Remarks

This paper is submitted in response to the Office Action mailed October 6, 2004. Reconsideration of the application is requested in view of the foregoing amendments and the following remarks.

RED - LINE

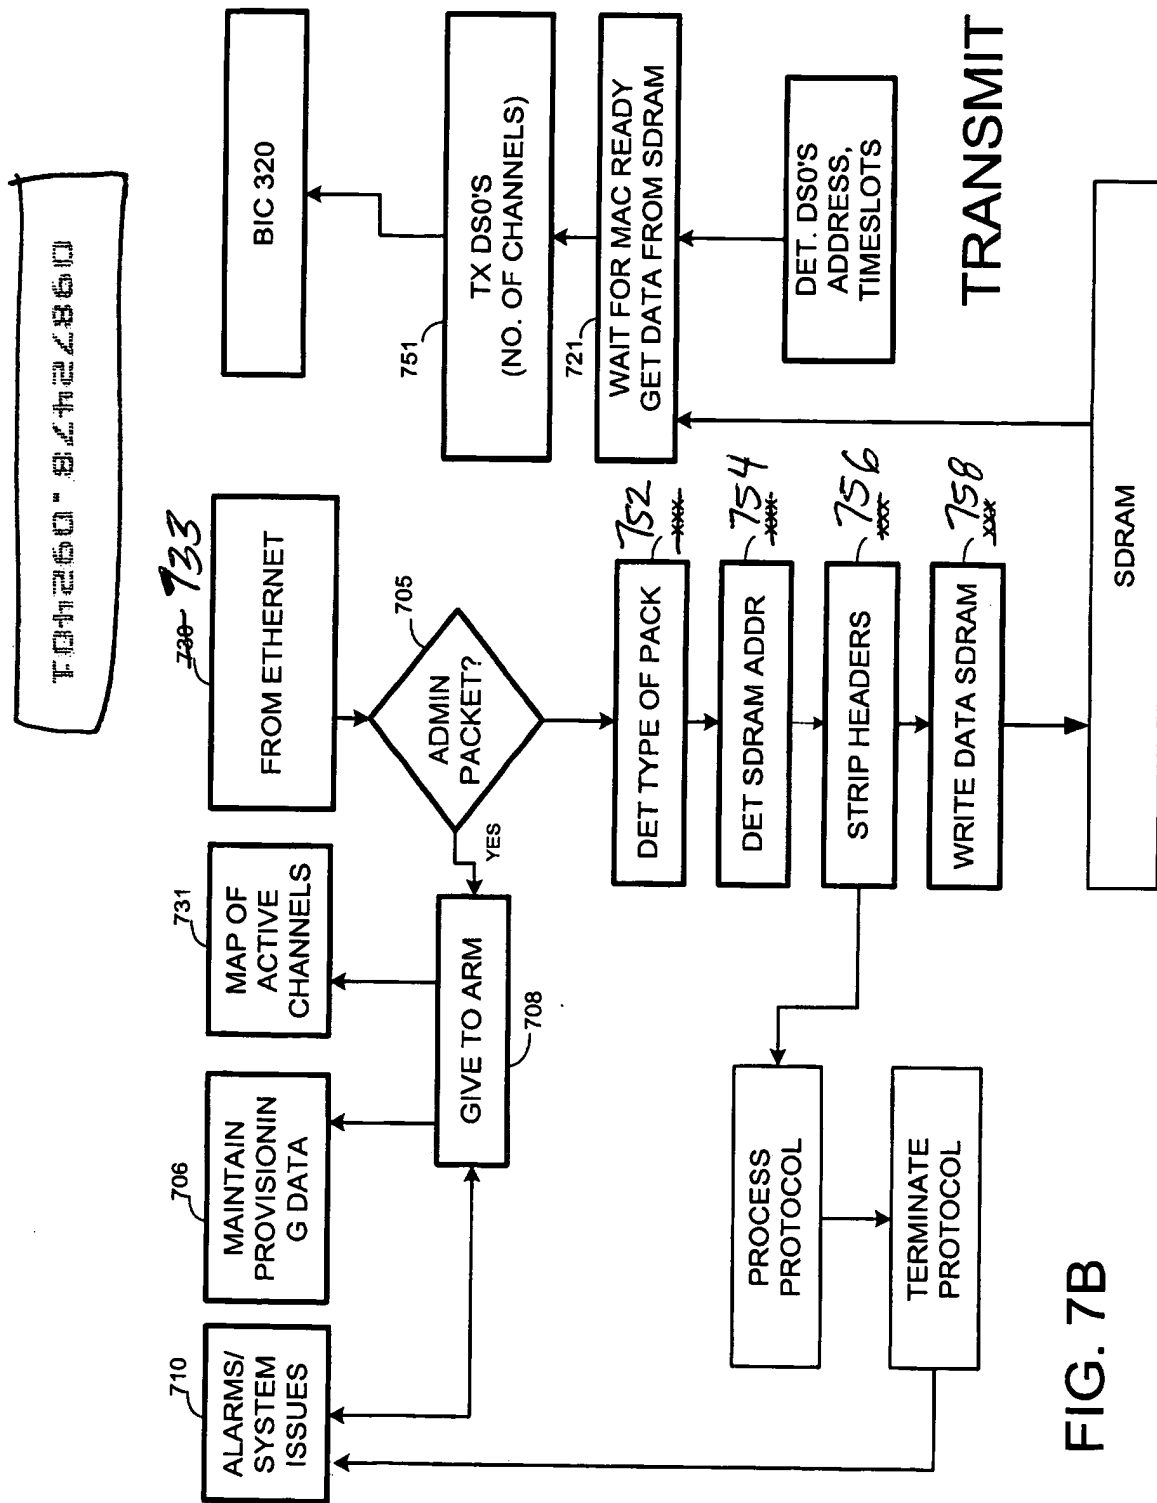
Figures 1 and 2 are amended by submission of Replacement Sheets to correct the informalities noted by the Examiner; namely, to add reference numbers that appear in the specification but were omitted in the drawings. Additionally, figure 7B is amended to add reference numbers to elements not previously numbered, and to change reference "730" to "733" as 730 was already used in figure 7A. A red-line copy of figure 7B is enclosed showing the changes. Acceptance of the revised drawings is requested.

1. Amend drawing figures 1, 2 and 7B by substituting the appended Replacement Sheets.
